Access Compliance Report

Public Rights-of-Way (Curb Ramps)

Intersection ID: 14594	Main Street: MONTICELLO_TR	Cross Street: E_MOREHEAD_ST	Location: NE
ADA ID: B2C05D1C9CEE	Ramp Type: PerpDiag	Initial Pass/Fail: Fail	Overall Compliance: No
Severity Score: 21.25			
Codes/Mitigation Info/Possible Solution		Field Measurements/Component Compliance

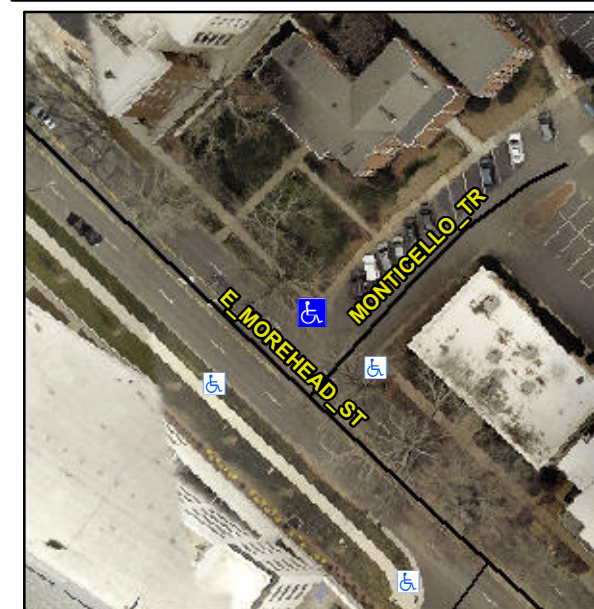
Not Found, R304.5.1, R304.2.2

Compliance	Description	Data	Compliance	Description	Data
N/A	Ramp Length (in)	77.0	No	Ramp Slope (%)	10.5
No	Ramp Width (in)	44.0	Yes	Ramp XSlope (%)	0.9
N/A	Flare Type LT	N/A	N/A	Flare Type RT	N/A
N/A	Flare Slope LT (%)	N/A	N/A	Flare Slope RT (%)	N/A
N/A	Flare Traversable LT?	N/A	N/A	Flare Traversable RT?	N/A
N/A	Landing Length (in)	N/A	N/A	DWS Provided?	N/A
N/A	Landing Width (in)	N/A	N/A	DWS Contrast?	N/A
N/A	Landing Slope (%)	N/A	N/A	DWS Length (in)	N/A
N/A	Landing X Slope (%)	N/A	N/A	DWS Full Width?	N/A
N/A	Landing Curb? (Y/N)	N/A	N/A	DWS Offset (in)	N/A
N/A	Shared Landing?	N/A			
N/A	Gutter Ponding?	N/A	N/A	Gutter Slope (%)	N/A
N/A	Gutter Lip Ht (in)	N/A	N/A	Gutter X Slope (%)	N/A
N/A	Painted X Walk1?	No	N/A	Painted X Walk2?	No
	X Walk 1 Direction	To SW		X Walk 2 Direction	To SE
N/A	X Walk 1 Width (in)	N/A	N/A	X Walk 2 Width (in)	N/A
	X Walk 1 Slope (%)	3.7		X Walk 2 Slope (%)	0.1
	X Walk 1 X Slope (%)	3.0		X Walk 2 X Slope (%)	2.2

Remove & Replace Curb Ramp With Two New Directional Ramps or Equivalent.
